City of
Richmond

Report to Development Permit Panel

File: DP 16-741741

Re: Application by Vancouver Airport Fuel Facilities Corporation (VAFFC) for a
Development Permit at 15040 Williams Road

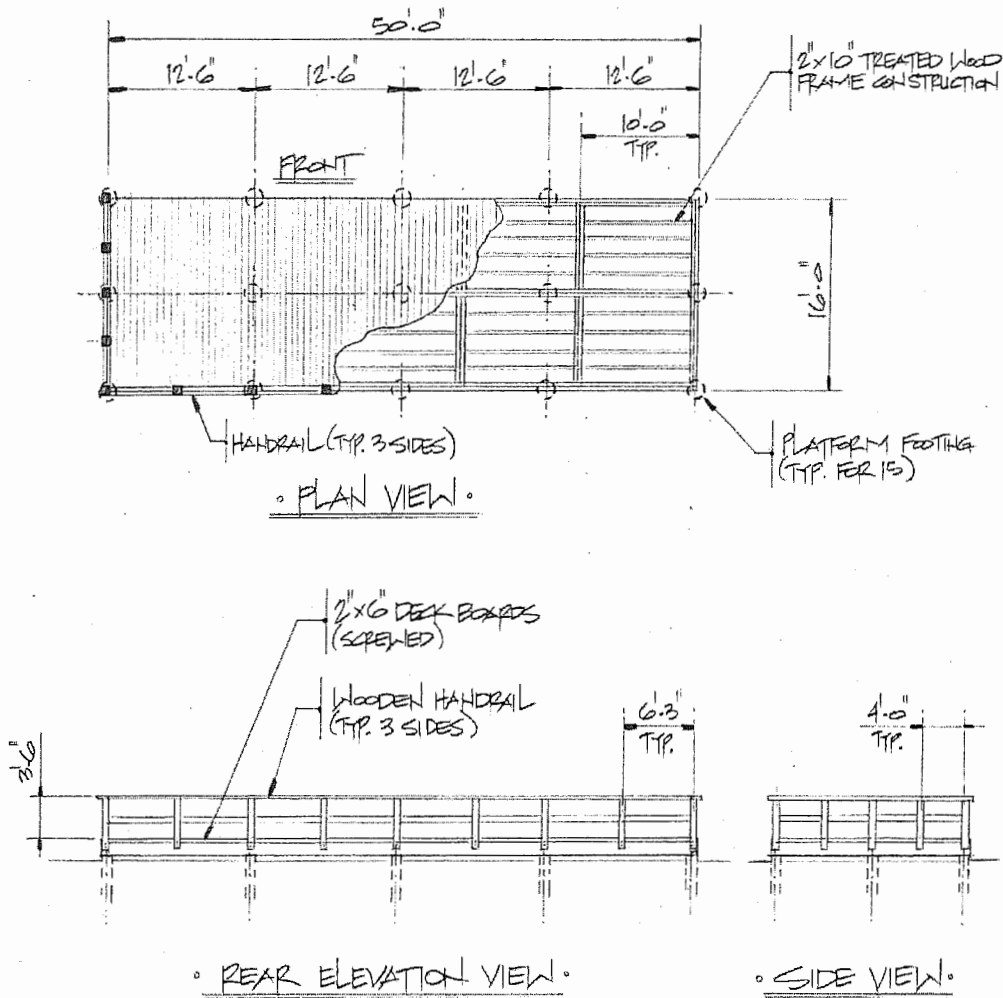
Panel Comment: ***That staff review the adequacy of the pedestrian viewing platform cash-in-lieu contribution and report back.***

Staff Response: A detailed cost breakdown for the proposed observation platform (refer to Attachment D), as provided by the applicant's contractor, has been reviewed by Parks Department staff.

The design is essentially a short treated wood frame construction platform with a protective wooden handrail at its perimeter. The platform will sit atop wood footings to provide an overlook to the Fraser River and would be similar to observation platforms used in various locations in Richmond. The platform would not be intended to project out significantly from the dike and would not extend past the high water mark. The basic design is shown in Attachment D.

Plan #14

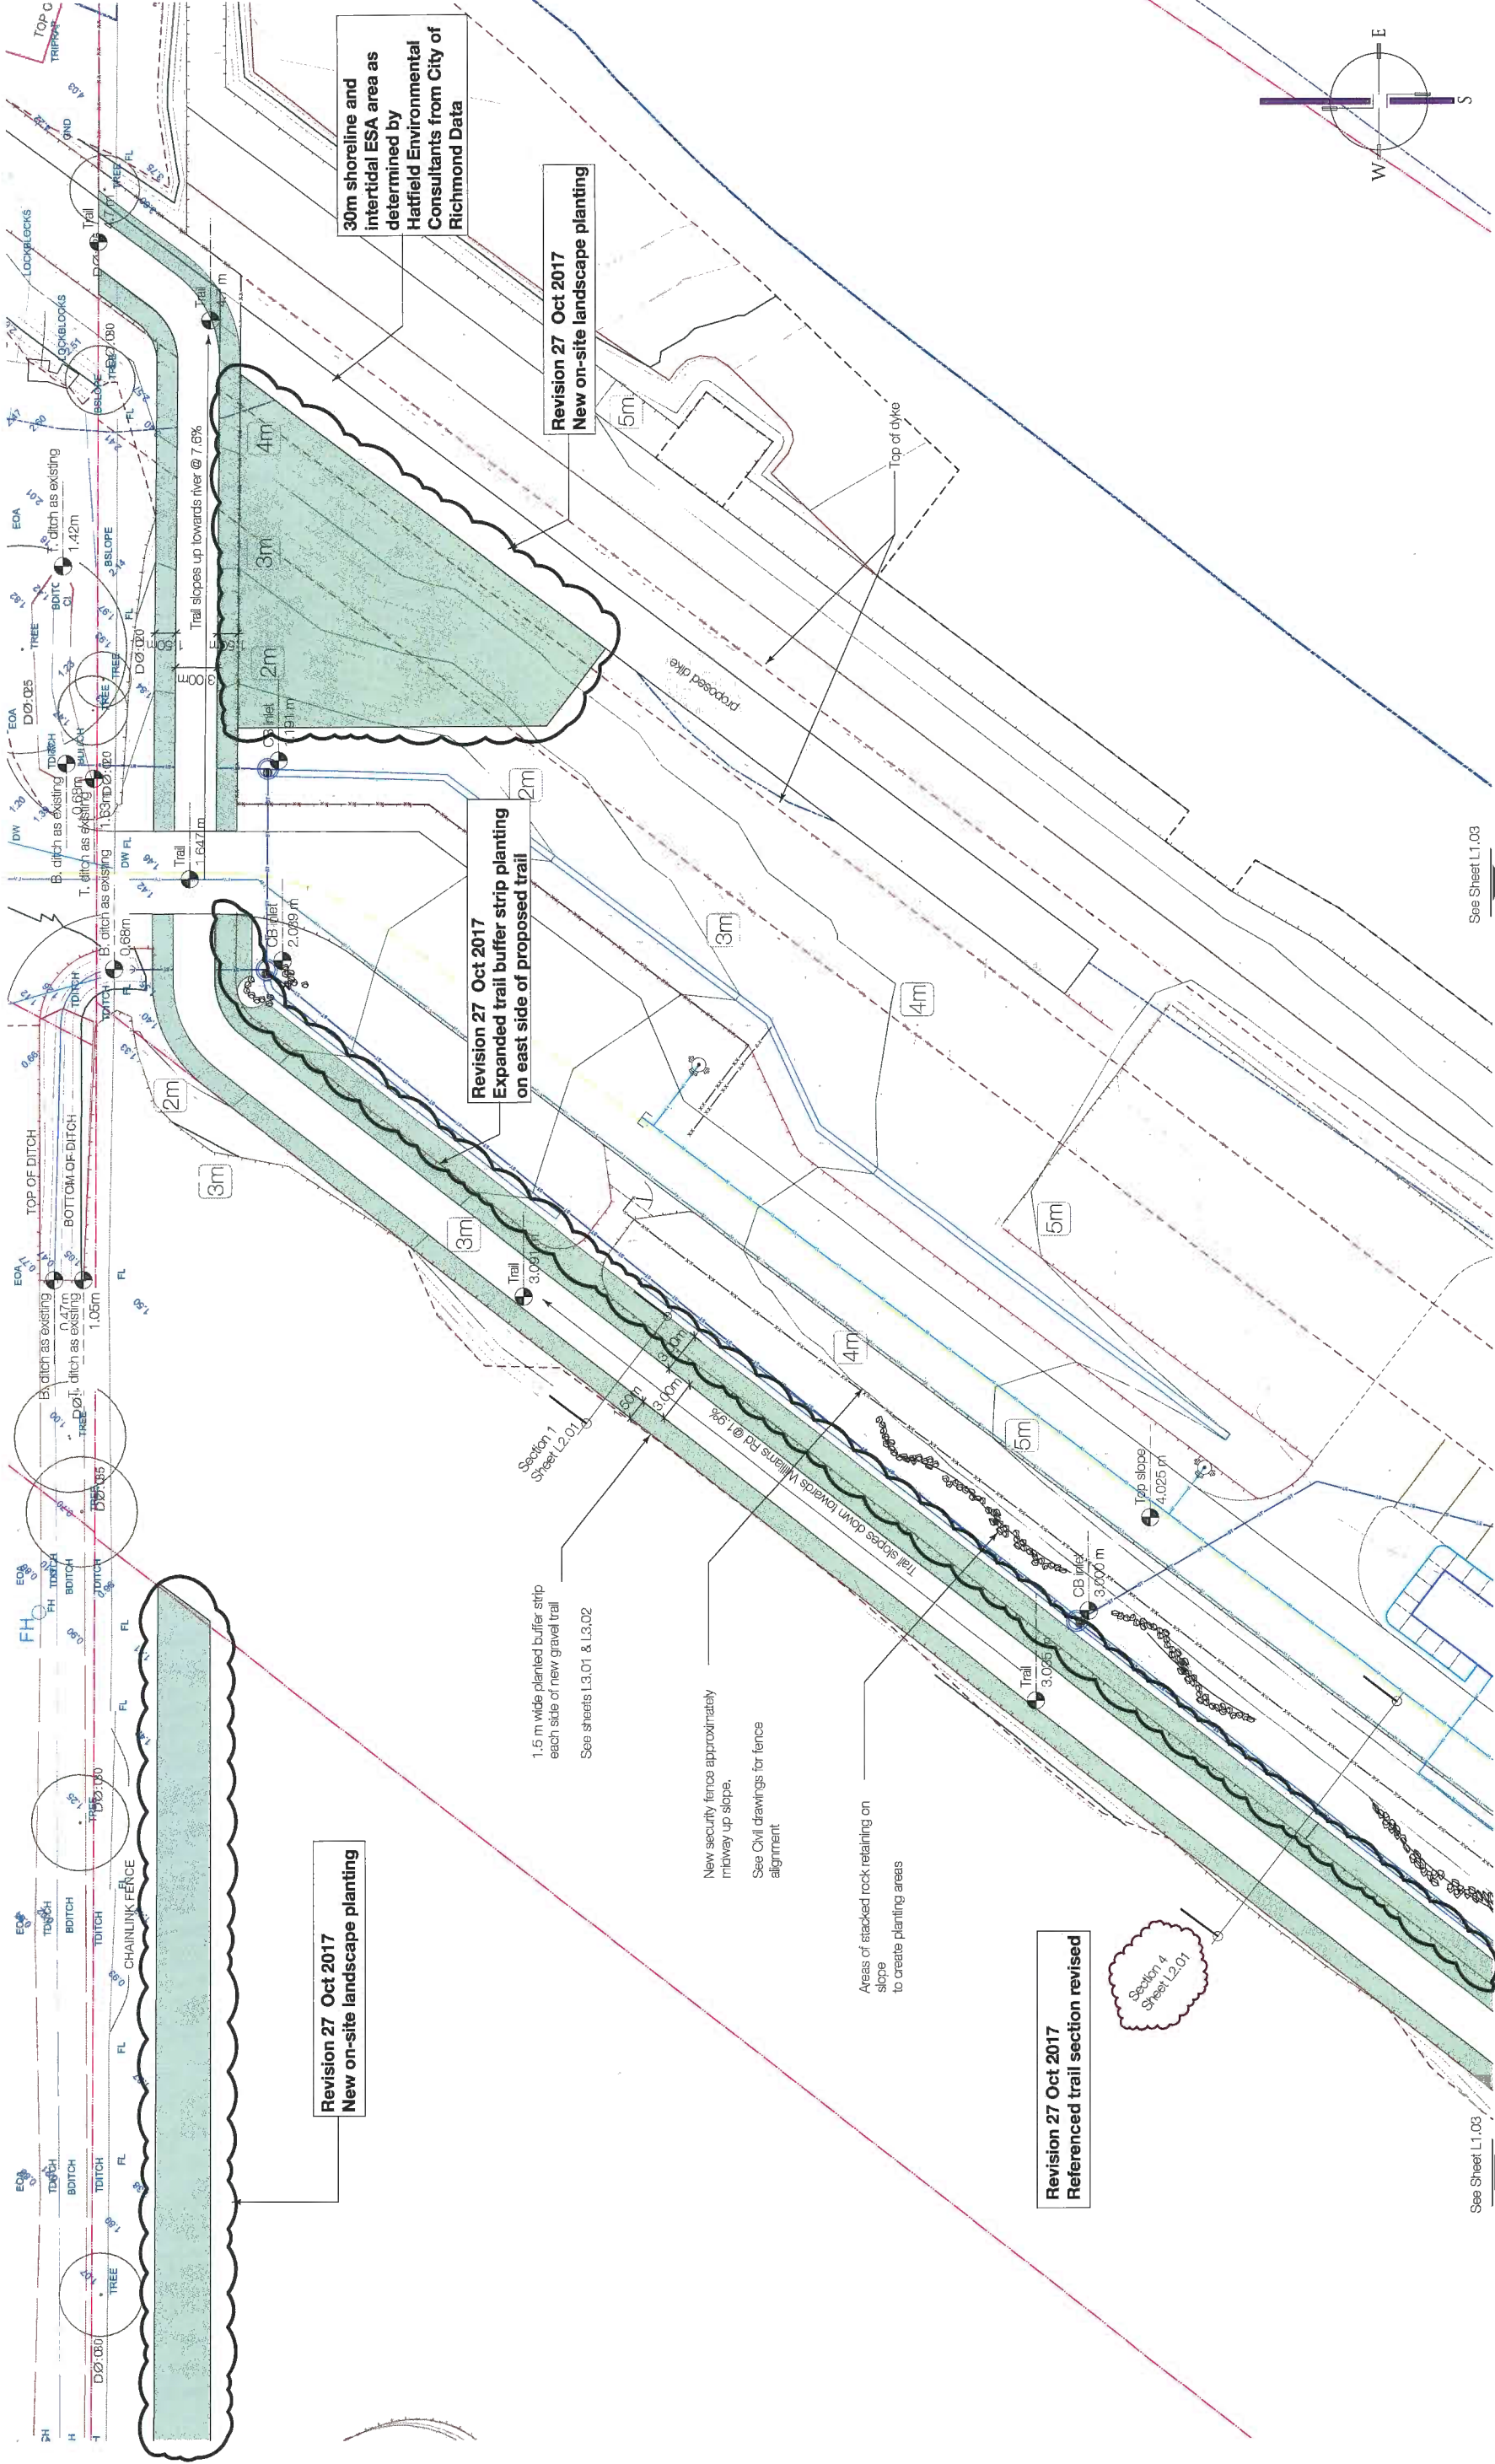
Panel Comment: *Review the proposed mitigation, compensation and enhancement scheme for shoreline ESA based primarily on existing ESA condition in the subject site and investigate opportunities for additional on-site ESA planting.*

The VAFFC response provides two new shoreline ESA planting areas to the site plan (refer to Plan #15). The first is a new 352 m² shoreline ESA planting area with additional trees, shrubs and herbs at the southwest corner of the site. The second is a new 350 m² shoreline ESA planting area with short shrubs and herbs at the northeast corner of the site.

4. An additional 645 m² (6,942.7 ft²) of non-ESA/RMA landscaping has been added via a new 400 m² (4,305.6 ft²) trailside planting area in the northeast corner of the site and a new 3 m wide planting strip adjacent to the Williams Road RMA north of the CN Rail (refer to Plan #15).

Revision 27 Oct 2017
Trail buffer planting expanded by 1.5m to create 3.0 m. wide planting strip on east side of trail, in addition to proposed slope planting. Expanded trail buffer and slope planting provide 660 sq. m. landscaped area.
